27 - 35 Meadowvale Road – Zoning and Subdivision Applications – Request for Direction

Date:	March 12, 2007
To:	Scarborough Community Council
From:	Director, Community Planning, Scarborough District
Wards:	Ward No. 44 – Scarborough East
Reference Number:	File Nos. 06 128381 ESC 44 OZ and 06 128385 ESC 44 SB

Attachment 1: Proposed Draft Plan of Subdivision

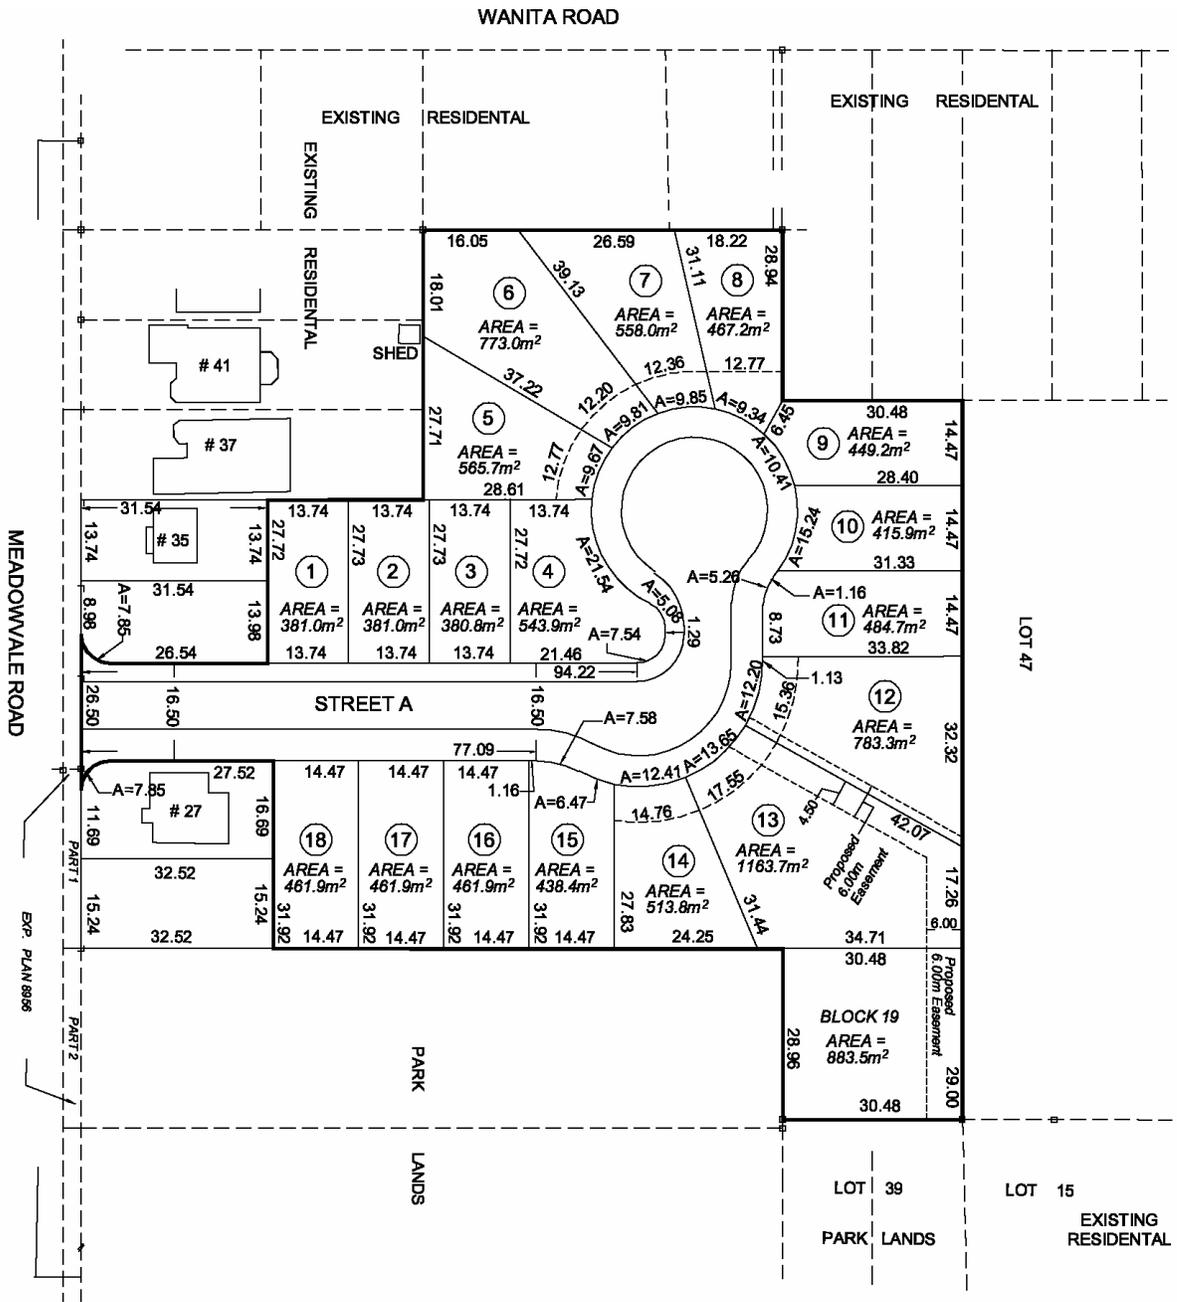
Lots 1 to 4 of the proposed draft plan of subdivision are located on the north side of proposed Street "A". Lots 1 to 3 are proposed to have lot frontages of 13.74 metres (45 feet) and lot depths of 27.73 metres (90.9 feet), resulting in lot areas of 381 square metres (4,101 square feet). All of the proposed dimensions for these lots are smaller than those typically found in this neighbourhood. Lot 4 is irregularly shaped, and has a larger frontage than the preceding three lots. As a result its lot area is 543.9 square metres (5,855 square feet). The proposed lot depth of 27.73 metres (90.9 feet) is smaller than the typical depth of lots in this neighbourhood. In the case of other lots in this neighbourhood where lot depths are shallow, their lot frontage is generally larger than that required by the zoning by-law, resulting in lot areas that meet zoning standards.

Lots 5 to 8 are pie-shaped lots situated on the west and north sides of the proposed Street "A". The lot frontages, measured at the street line, range from 9.3 metres (30.5 feet) to 9.85 metres (32 feet). The proposed lot areas range from 467.2 square metres (5,029

square feet) to 773 square metres (8,320 square feet). The lot lines proposed by the applicant result in lots that may pose difficulties for siting dwellings on the lots. The house siting plan prepared by the applicant shows unique dwelling footprints on each of these proposed lots. The developer has indicated that once approved, the lots are likely to be constructed by a builder and not themselves.

While the zoning by-law amendment application does not currently seek relief for side yard building setbacks on internal lots, it may be required for a builder in the future who, according to the house siting plan, may have to custom design dwellings for each lot. While a street tree planting plan has not yet been submitted for review, the house siting plan illustrates potential locations for street trees along proposed Street “A”. The configuration of Lot 5 to 8, along with the proposed driveways leaves very little room in the boulevard for street tree plantings. Urban Forestry staff have indicated that the width of the driveways and utility installations may prohibit street tree plantings. This is not acceptable and it may be necessary to use single width driveways for these lots, including Lot 9, to accommodate street tree plantings.

As currently proposed, the projected limit of the west side lot line of Lot 1 on the proposed plan extends beyond the southerly building face of the existing dwelling at #37 Meadowvale Road. This raises concerns of privacy, overlook and impact on rear yard amenity space caused by the location of Lot 1 in relation to the existing dwelling at #37 Meadowvale Road.

As currently proposed, the existing dwelling at #23 Wanita Road extends to just beyond the projected limit of the rear property line of proposed Lot 8. The applicant’s house siting plan does not address the relationship between the existing dwelling and the proposed house siting of Lot 8. This raises concerns regarding adequate distance

separation from the existing dwelling, and impact on both the existing and the proposed rear yard amenity space. Staff have asked the applicant to submit a revised house siting plan which illustrates this relationship in order to better assess this issue.

A street tree planting plan is required from the applicant. As outlined earlier, the use of double width driveways and utility installations may prohibit street tree planting on Lots 5 to 9. This is not acceptable and it may be necessary to use single width driveways for these lots in order to accommodate street tree planting.

Technical Services staff have reviewed the current proposal and, instead of an overland flow easement over Lots 12 and 13, they are recommending these lands be conveyed to the City as an overland flow and storm sewer block. Conveyance of this land to the City would ensure that the area would be accessible at all times for maintenance and that the overland flow swale will remain free of obstructions. Technical Services staff request that a 1.8 metre (6 feet) high chain link fence be provided along the lot lines of Lots 12 and 13 adjacent to the overland flow route. This issue has not been resolved and will have to be addressed by the applicant in consultation with Technical Services, Parks and Planning staff. If conveyed to the City as a block of land, maintenance considerations will need to be addressed between the applicant and the City.

A further consequence of conveying portions of Lots 12 and 13 is that their resulting lot frontages and areas would be reduced.

A pedestrian sidewalk having a width of 2.0 metres (6.6 feet) will be required adjacent to the curb extending from Meadowvale Road to proposed Lot 10. The current grading plan does not meet with this requirement, and must be revised.

The applicant will need to address the concerns raised by staff with respect to lot size and configuration to make the lots more compatible with the existing pattern of development in the surrounding neighbourhood through revisions to the proposed draft plan of subdivision. As currently proposed, the lots do not meet the policies of the Official Plan, Section 4.1.5 Neighbourhoods, which sets out that development in established Neighbourhoods will respect and reinforce the existing physical character of the neighbourhood, including in particular, the size and configuration of lots. The policies also state that no changes will be made through rezoning, minor variance, consent or other public action that area out of keeping with the physical character of the neighbourhood. To address the concerns of staff, modifications to the proposed draft plan of subdivision are recommended.

Increasing the size of proposed Lots 1 – 4 would allow more room to site the proposed dwellings on the lots. In the case of Lot 1, it would provide for more space on the lot to separate the proposed dwelling from the dwelling at 37 Meadowvale Road and to plant screening material between the existing dwelling and the proposed dwelling, thereby reducing the impact on both the existing and the proposed rear yard amenity spaces.
